SERVICE BULLETIN SS-MAR0234	model number 4220	bulletin number M-4220-1
	for serial numbers ALL	
	subject DRIVER IC REPLACEMENT	
	engineering approval 	date 11-25-75

model number 4220	bulletin number M-4220-2
for serial numbers ALL	
subject SERVICE MANUAL CORRECTION	
engineering approval D. Almeida 7-14-76	date 5/20/76

This Service Bulletin corrects an schematic error on page 12 of the Marantz Model 4220 Service Manual.

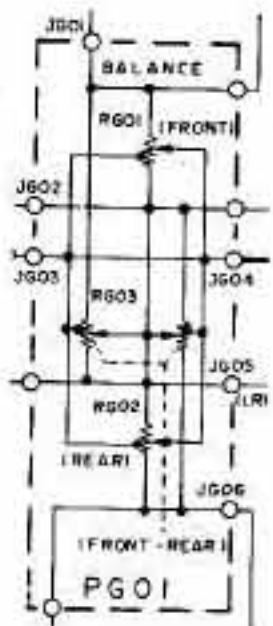
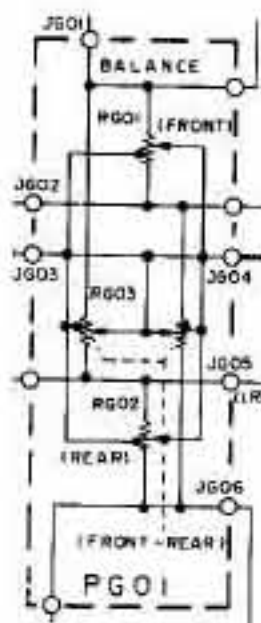
INCORRECT

CORRECTED

Incorporate this change into your Service Manual to ensure proper reference information.
